SITE PLAN EVALUATION SHEET

Response to City Staff Comments dated May 11, 2009, specifically

Quality of Wetlands Proposed to be Partly or Completely Removed
Hatchet Creek Design Plat (PZ-09-19), Mark A. Garland, Environmental
Coordinator, City of Gainesville
April 8, 2009

Photo 5. View from north to south of culvert that routes water from the well field to the project site. This is the major hydrologic connection of the project site to all areas north of 53rd Avenue.

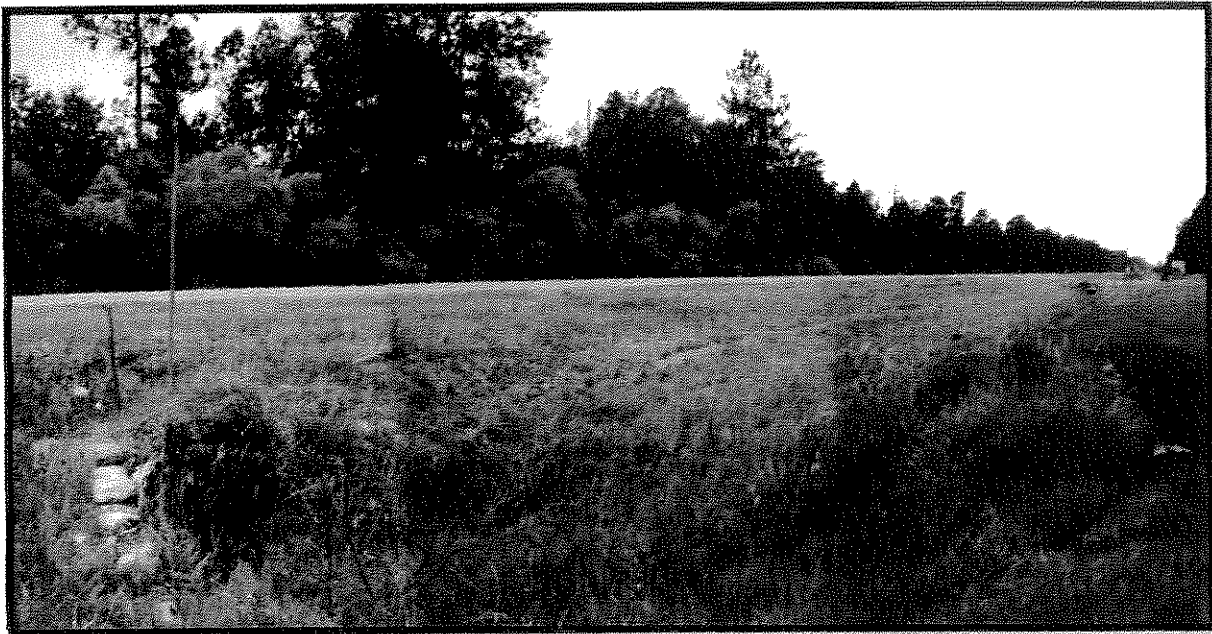
Comment 4: Location—These wetlands have a high value because of their location. Alachua County designated this area as part of its Buck Bay Flatwoods Strategic Ecosystem. The 1996 KBN/Golder report summarizes this area as follows (emphasis added): "This is a large site of commercial pine flatwoods forest and associated wetlands directly north of Gainesville. It is a major headwaters area, rather like a miniature Green Swamp, supporting the following creek systems to varying degrees: Rocky Creek, Montechoa Creek, Rhuda Branch, Hatchet Creek, Little Hatchet Creek, and a bit of Hog town Creek Wetlands occupy large areas and provide a lot of surface water storage and wildlife habitat."

Response: The current project site, although previously mapped by the County as part of the Buck Bay Flatwoods Strategic Ecosystem, is effectively isolated from this system (Figure 1 and Photos 1 through 11). The project site is isolated from all parts north of the site by NE 53rd Avenue; all points west by NE 15th Street; areas to the south by NE 39th Avenue, and areas to the east by Waldo Road and the Airport. The only direct connections to the north, west and south are provided by a series of five (5) culverts that receive flow from upstream areas. To the north of the site lies the Buck Bay Flatwoods
